RESPONSE TO NRC REQUEST OF 06/09/78... FURNISHING ADDL INFO CONCERNING SUBJECT
FACILITY'S CONTAINMENT TENDON SURVEILLANCE PROGRAM... W/ATT DIAGRAMS.

H. B. ROBINSON STEAM ELECTRIC PLANT, UNIT NO. 2
DOCKET NO. 50-261
LICENSE NO. DPR-23

ADDITIONAL INFORMATION - CONTAINMENT TENDON SURVEILLANCE PROGRAM

SURVEILLANCE
TENDON CAPSULE

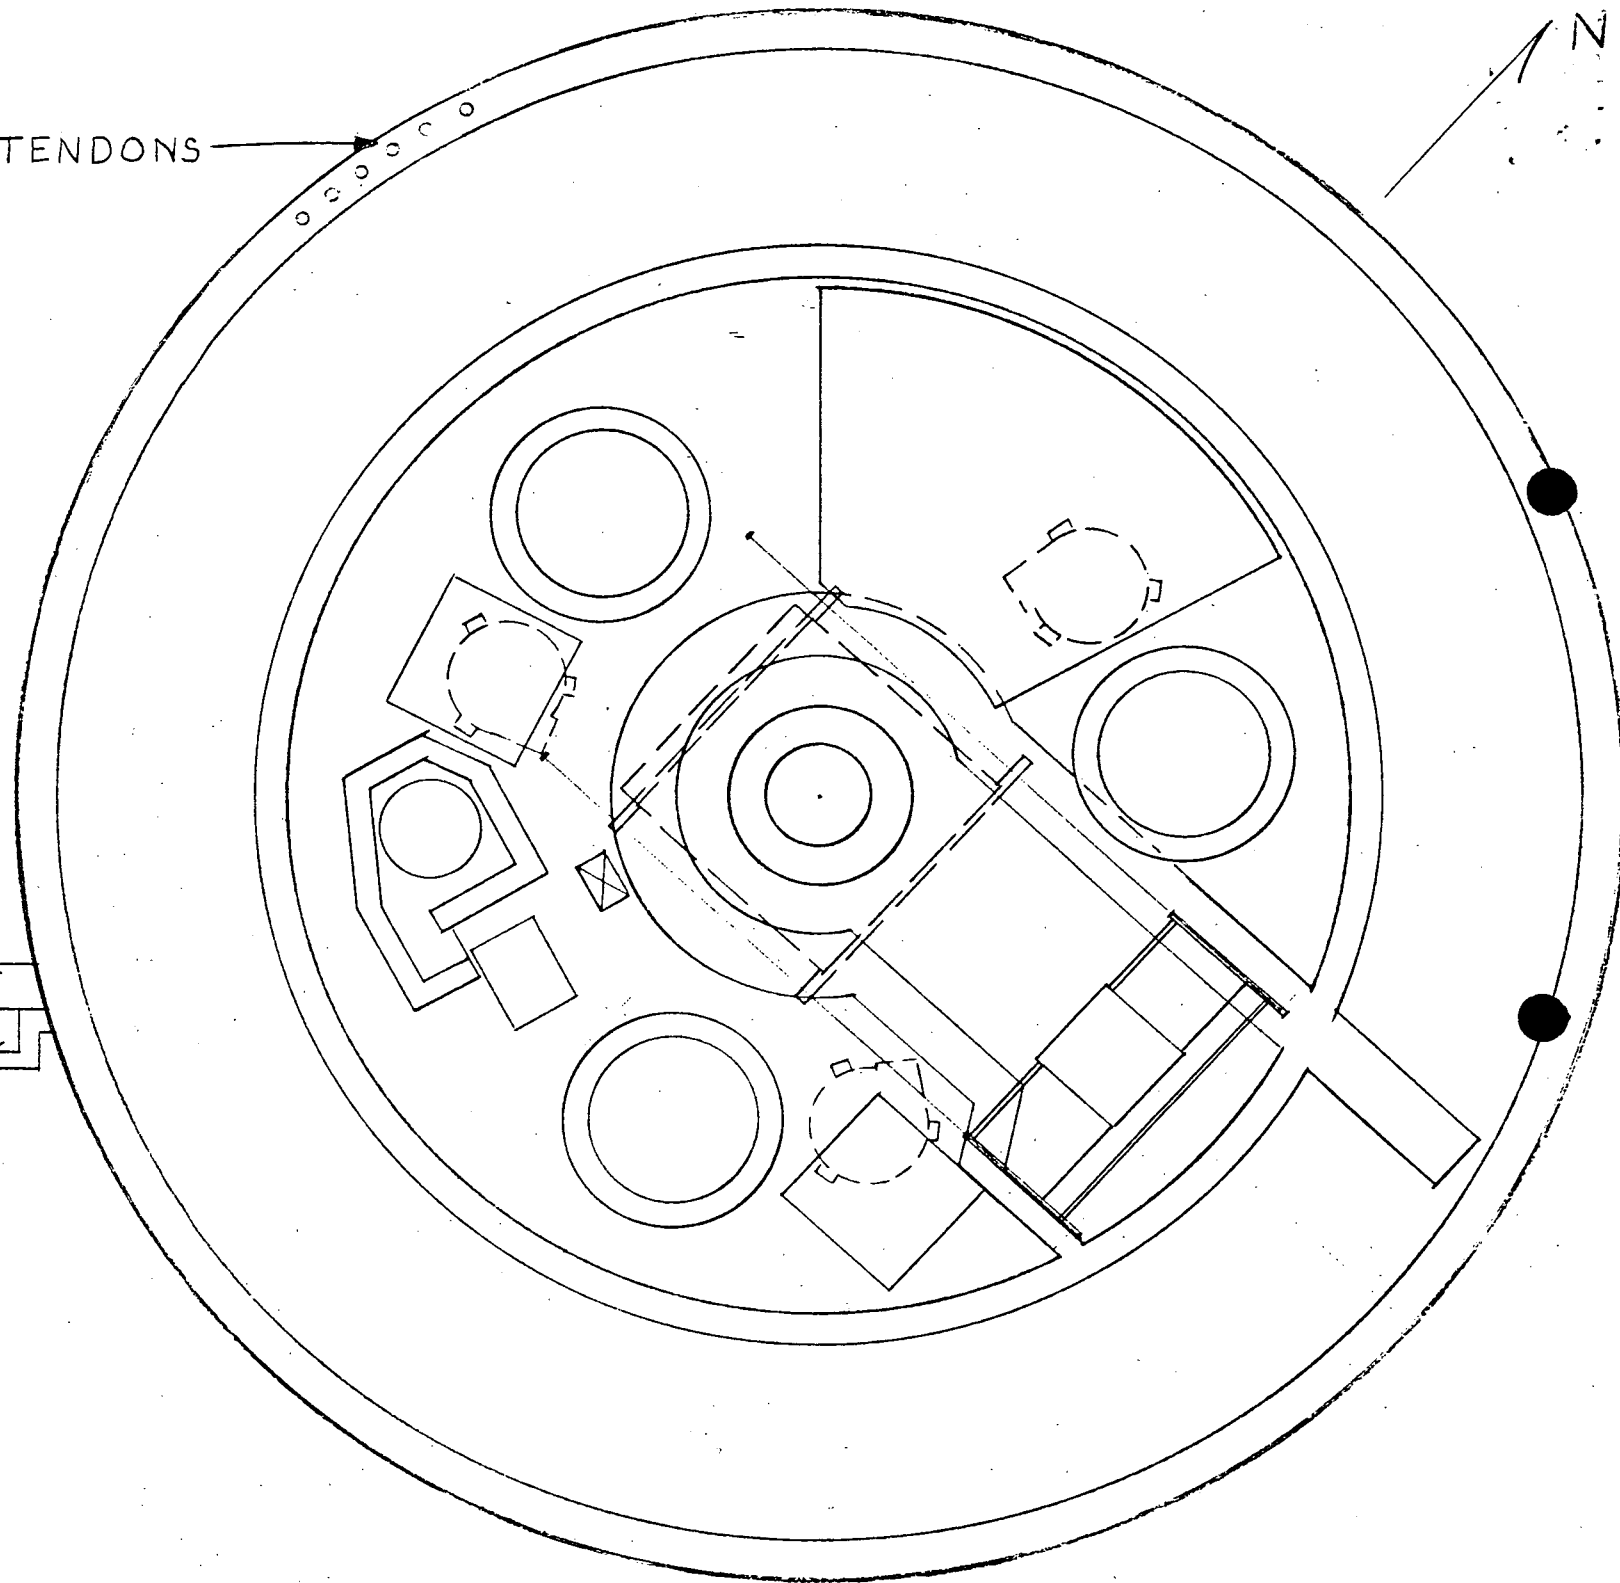
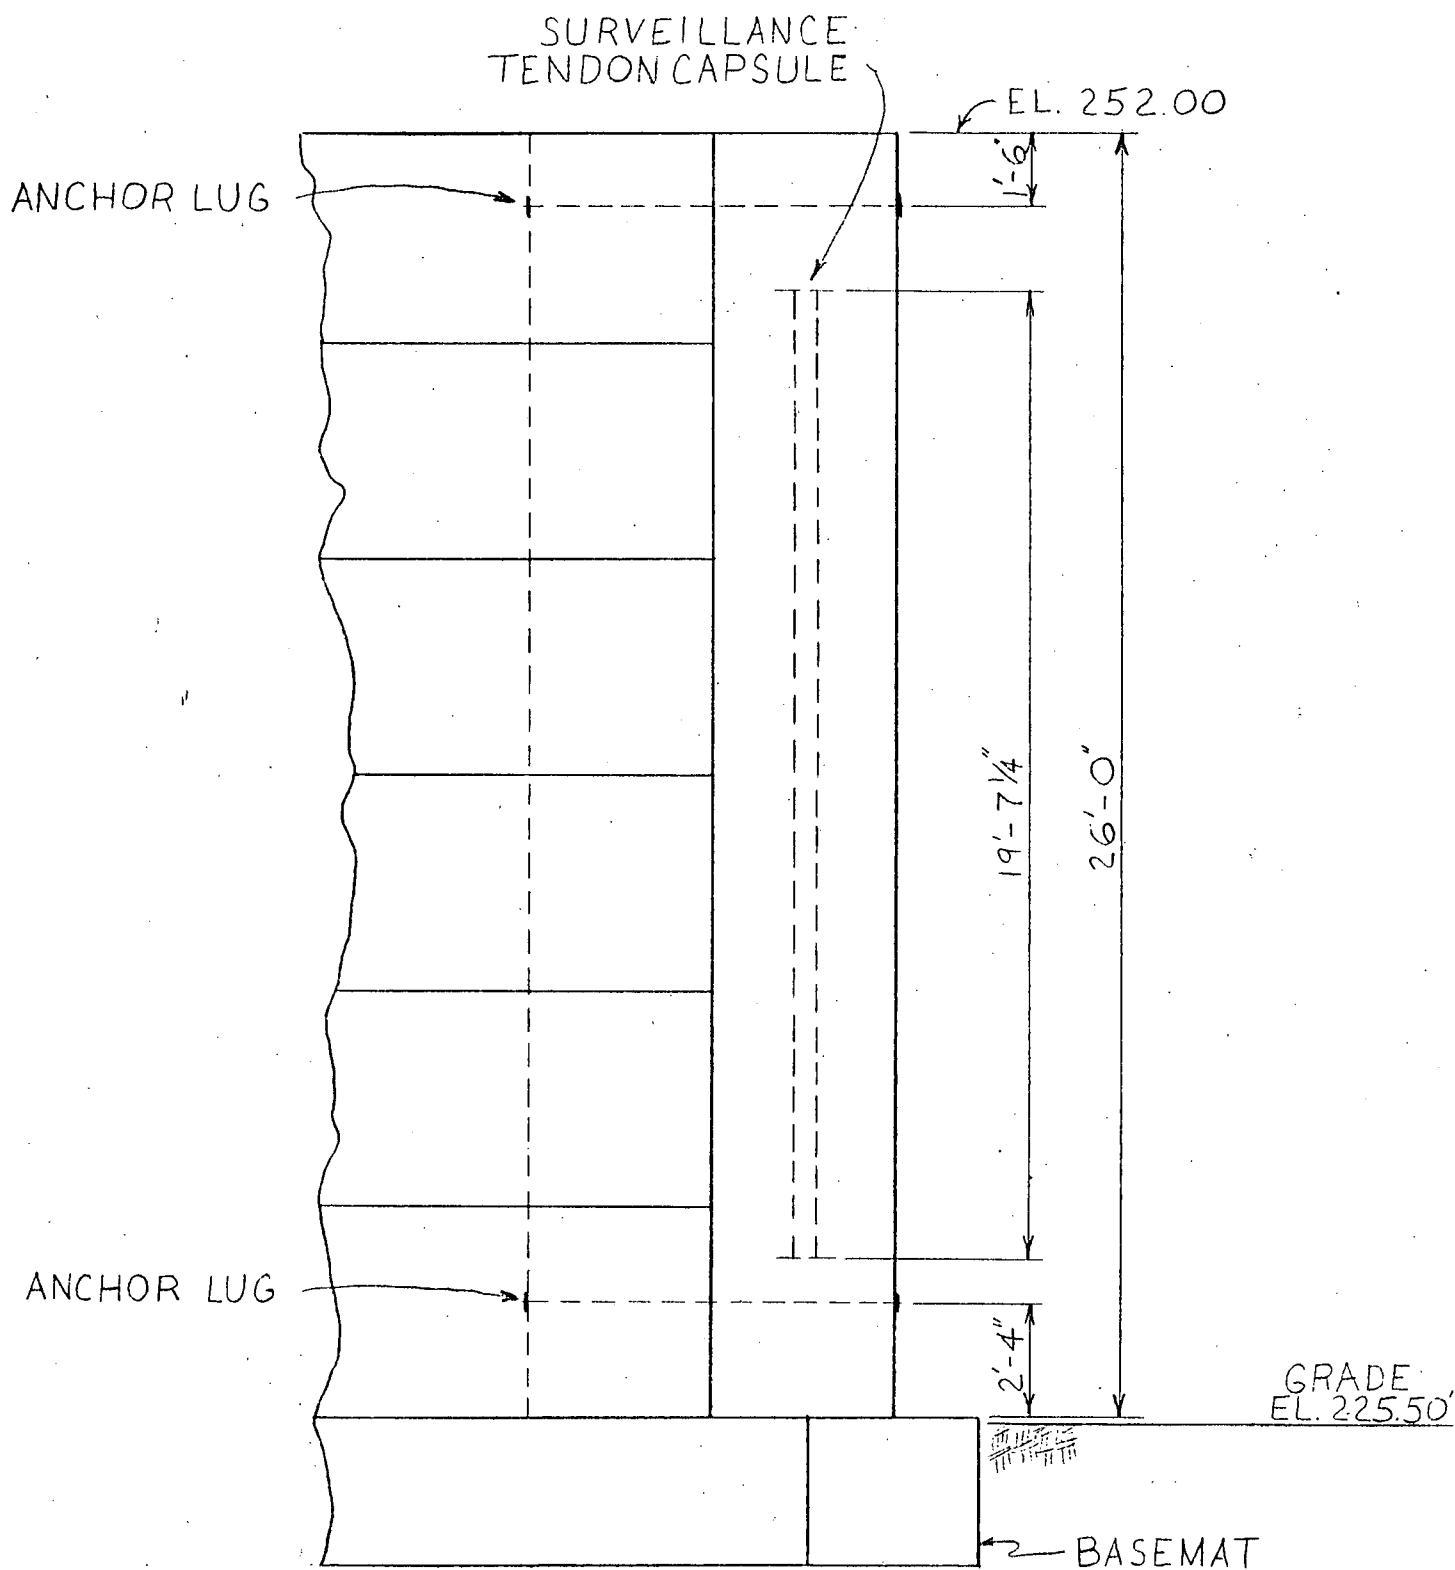
Question A.3. Considering the past history of some corrosion of the bars in the main tendons, discuss the relevancy of the results of the tests on the special surveillance tendons for a conclusion as to the soundness of the main tendons. Provide a sketch indicating in detail the location of the special surveillance tendons with respect to the containment structure and the main tendons. Indicate their length.

Question B.1. Figure 1, page 2, of this report shows the orientation of the tendon, but not with respect to the containment structure. Indicate this orientation on the sketch requested in A.3, above.

Response: The attached sketches show the relative location of the surveillance tendons to the containment as well as the dimensions of the capsule.

Response: Refer to attached sketches.
